**INDEPENDENT AUDIT OF COMPLIANCE
WITH EPBC 2019/8530**

**Holcim Colac Quarry,
75 – 95 Potters Road, Ondit VIC**

August 2025

Figure 5 Conceptual drawing of habitat creation

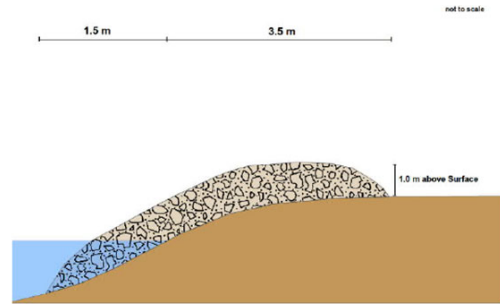
4.2.4 Design					
	<p>Follow the description in Section 3.3.2 of Biosis Research (2007) and schematic in Figure 5 below which includes:</p>	Visual Inspection	Areas of created habitat were visually inspected on Tuesday 16 August 2025 as part of the audit and appeared to generally follow the description in section 3.3.2 of Biosis Research 2007 and schematic in Figure 5 (an example is shown in the photo below located on the northern bank of Basin 6).

Use rock overburden from quarry operation (mix of some soil and mostly rock)	Visual Inspection	Rock overburden from the quarry operation was observed to have been used for habitat creation and was comprised of mostly rock.	C	
Create piles that are:	Visual Inspection	Piles appeared to be a minimum 25 lineal metres along the water edge	C	
<ul style="list-style-type: none"> - Minimum 25 lineal metre sections along the water edge spaced intermittently. - Minimum width of 5 metres: - Extending approximately 1.5 metres into the water. - Extending approximately 3.5 metres out of the water (Basin 4, Basin 6, Stage 6 rehabilitation) or approximately 1 metre above the 118m AHD water level on the bund between Basin 1 and Basin 3. - Average of 1 metre height of rock pile above ground surface level. - Comprised of a variety of rock sizes to create a high proportion of rock crevices as refugia for the skinks 	Visual Inspection	Piles appeared to have a minimum width of 5 metres, extended 1.5m into the water (noting that the water level was low during the visual inspection) and extending approximately 3.5m out of the water and approximately 1m above the 118 m AHD water level on the bund between Basin 1 and Basin 3. The piles also appeared to have an average height of 1m above ground surface and were comprised of a variety of rock sizes.	C

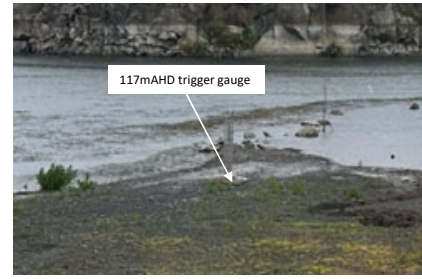
<p>5.3.2 Water Levels</p>			
<p>Water levels in the northern pits will be monitored to ensure they do not exceed the predicted maximum of 118 mAHD. The following measures will be implemented:</p>	<p>WSP - Surface water and Groundwater Monitoring Reports - March 2023, Sept 2023, March 2024, September 2024, March 2025</p>	<p>The March 2023, Sept 2023, March 2024 and Sept 2024 water monitoring reports revealed water levels in Basins 1, 2 and 3 of >116.4 mAHD, >116 mAHD and >116 mAHD respectively (except for Basin 3 in March and Sept 2024 which had a recorded water level of between 116 to <116.8 mAHD).</p> <p>The March 2025 water monitoring report revealed water levels in Basins 1, 2 and 3 of 116.3 mAHD, >116 mAHD and between 116 to <116.8 mAHD respectively).</p> <p>Whilst water levels in the northern pit are being recorded on a biannual basis, it is considered that the current reporting approach applied by the consultant is predominantly for the purpose of determining water volumes within the northern pit. As such additional records should be included in the biannual reports to clearly specify whether the water in the northern pits has reached the 117 mAHD trigger level and if the water is below the 118 mAHD specified level in the 2021 CWS Management Plan.</p>	<p>Request that the consultant undertaking the biannual water level monitoring in the northern pits, clearly specify whether the water in the northern pits has reached the 117 mAHD trigger level and/or if the water is below the 118 mAHD specified level in the 2021 CWS Management Plan.</p> <p>mnc</p>

<ul style="list-style-type: none"> • Monthly monitoring of water levels based on the water level gauge in the northern pits during Stage 5 and Stage 6 operations. 		<p>It is acknowledged that in February 2025, Holcim also commenced its own monthly recording of water levels in the northern pit, however monthly water level monitoring was not undertaken throughout the entire audit period.</p>	<p>Continue conducting monthly monitoring of water levels based on the water level gauge in the northern pits and keep records of the monthly monitoring.</p> <p>mnc</p>
<ul style="list-style-type: none"> • Setting of a trigger level of 117 mAHD for the Quarry Operator to initiate an evaluation of the rate of groundwater dewatering and remaining pit life of Stage 5 and Stage 6. 	<p>Visual inspection</p>	<p>A trigger gauge of 117 mAHD was observed in the northern pits (refer to photo below) during the visual inspection</p>	 <p>C</p>

CWS Mgt Plan 4.2.5, OMP 5.3.2	mNC	Continue conducting monthly monitoring of water levels based on the water level gauge in the northern pits and keep records of the monthly monitoring.
CWS Mgt Plan 5.2.4	mNC	In future salvage and release works, keep a record of the health evaluation of each individual CWS that is captured and released in accordance with the health evaluation requirements as outlined in Section 5.3.1 of the Holcim Colac Quarry Corangamite Water Skink Translocation Plan (Appendix B).
CWS Mgt Plan 5.2.4	mNC	In future salvage and release works, take high resolution photographs of the ventral surface of each individual Corangamite Water Skink caught in accordance with Section 5.3.3 of the Holcim Colac Quarry Corangamite Water Skink Translocation Plan (Appendix B).
CWS Mgt Plan 8-21 OMP 5.7-15	mNC	Provide clear demarcation for all habitat protected areas including the following areas identified in this audit as not demarcated:
